33.2.4.7 State diagrams

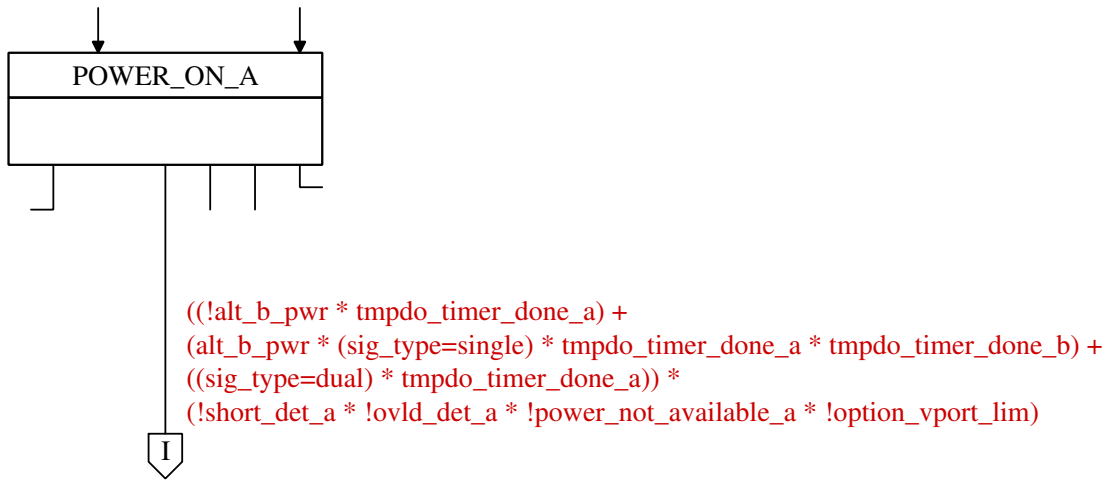
Change Figure 33-9b (continued) as follows:

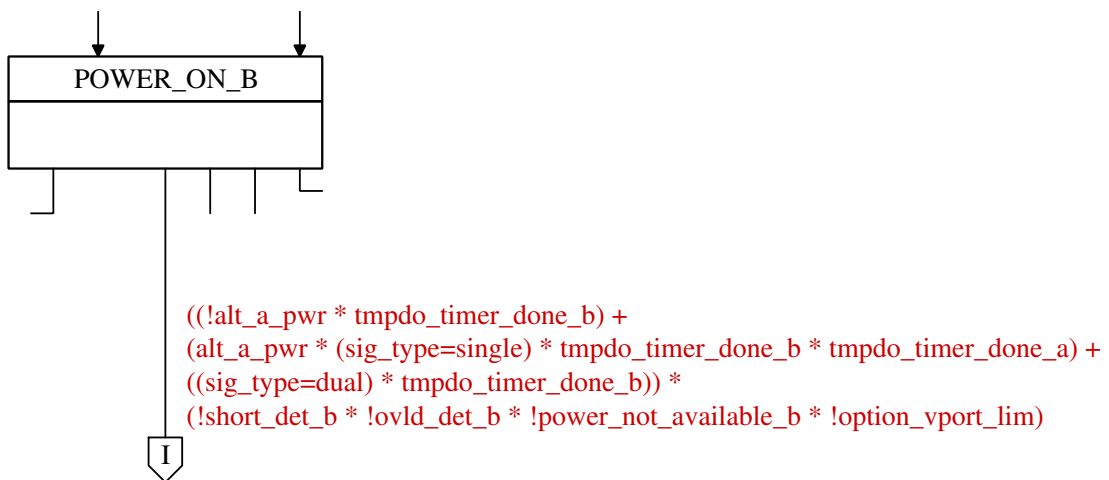
Change Figure 33-9c (continued) as follows:
